| Tolerance (Except as noted) |  Memory Protection Devices, Inc 200 Broad Hollow Road, Farmingdale, New York 11735 | | |
| | 07/29/11 | BK-5003 | |

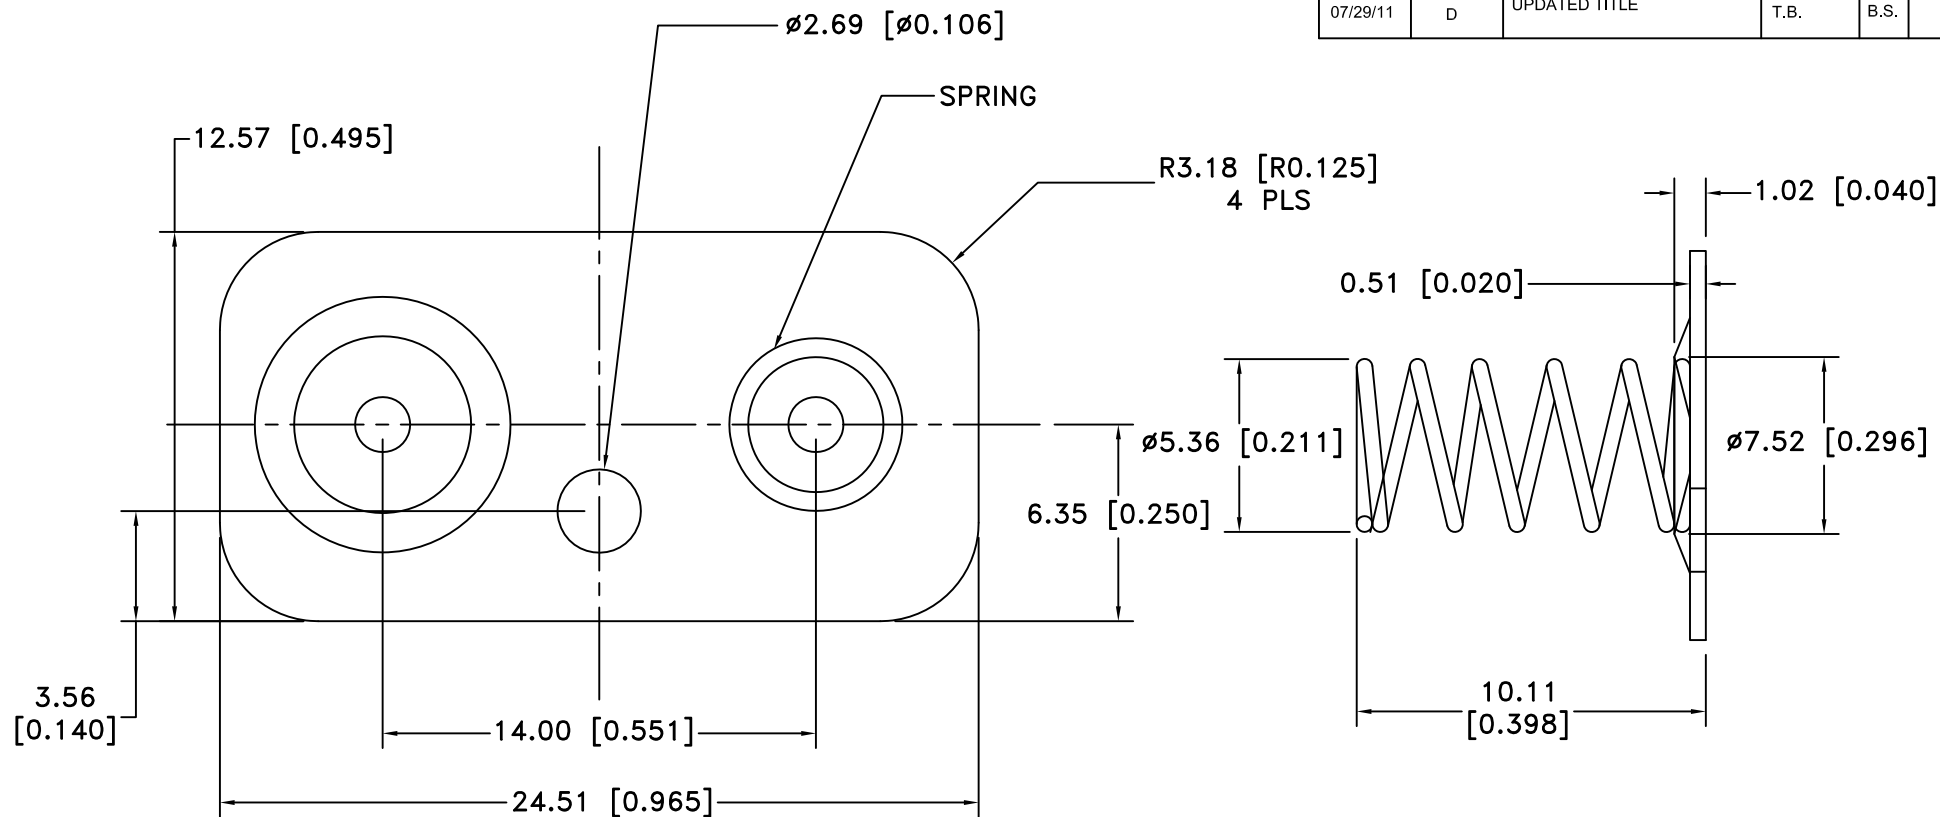
| Date | SYM | REVISION RECORD | AUTH | DR. | CK. |
|----------|-----|---|------|------|-----|
| 02/08/03 | B | (1) Ø5.36[0.211] WAS Ø5.59[0.220] (2) ADDED Ø7.52 [0.296] (3) 10.11±.25[0.398±.010] WAS 6.35±1.25 [.250±.050] (4) SPRING WAS 3 COILS | T.B. | B.S. | |
| 03/26/10 | C | REMOVED ALL TOLERANCES | T.B. | B.S. | |
| 07/29/11 | D | UPDATED TITLE | T.B. | B.S. | |
